WAITOMOKIA PRECINCT – RESPONSE TO RFI

You have submitted a plan change application to Auckland Council to create a new Auckland Unitary Plan (AUP) Precinct. The new Precinct is called Waitomokia Precinct and is located in Māngere, approximately 3km north of Auckland Airport. Appendix A shows the location plan.

Auckland Council has raised concerns about reverse sensitivity noise effects and has requested a noise assessment to address this. The request is reproduced below:

APPENDIX B ZONING

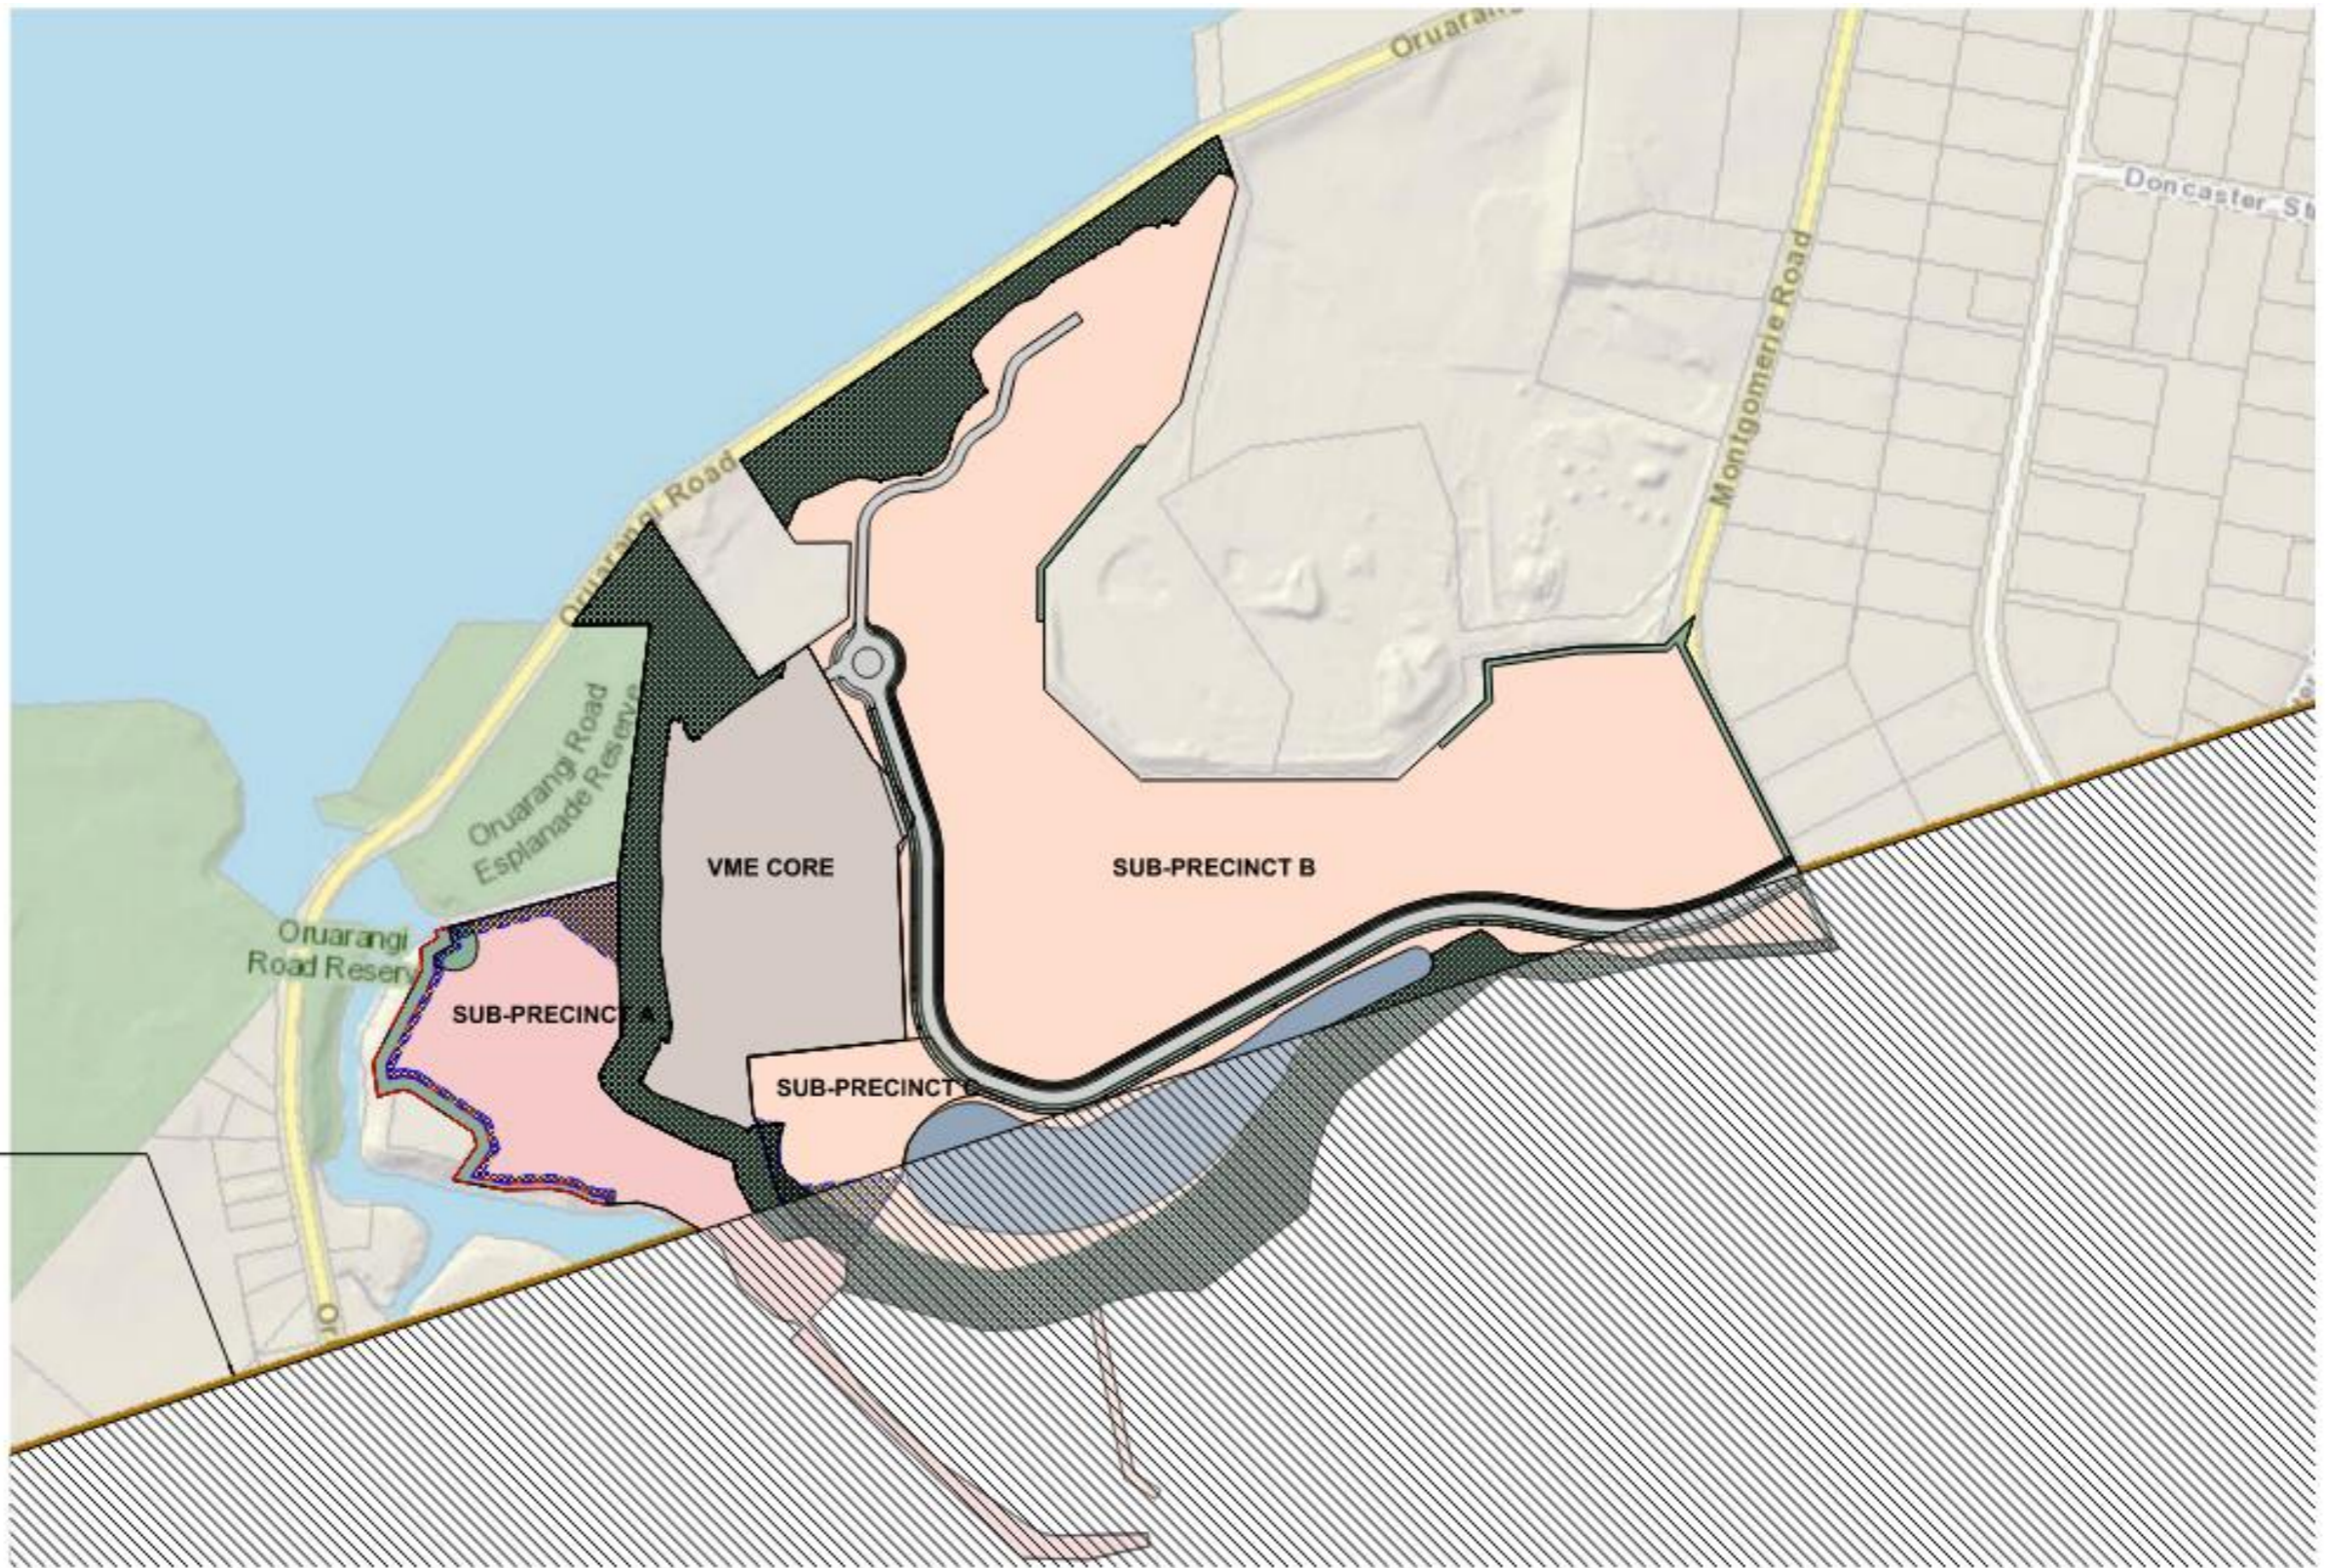
Please provide a noise assessment which assesses reverse sensitivity effects resulting from the proposed precinct provisions which seek to enable activities sensitive to noise within the plan change precinct area, and if deemed necessary by the assessment, amend the precinct provisions to ensure such effects are adequately addressed inside the plan change precinct area (note: as per AUP Chapter A1.7.3, restricted discretionary activities are generally anticipated by the AUP in the existing environment and this should be reflected in the requested assessment where the proposed precinct provisions seek to apply this activity status to precinct activities sensitive to noise when compared with the underlying Business – Light Industry Zone)

The Precinct is currently zoned as *Business – Light Industry* (see Appendix B). The plan change does not seek to change the zoning. The zoning maps also shows the Aircraft Noise Overlay in relation to the location plan. Goodman has shown this overlay on their master plan (see Appendix C). We consider that the Aircraft Noise Overlay does not cover any of the proposed building areas. We consider that there will be no reverse sensitivity effect on Auckland Airport.

There is no reverse sensitivity effect on Auckland Airport
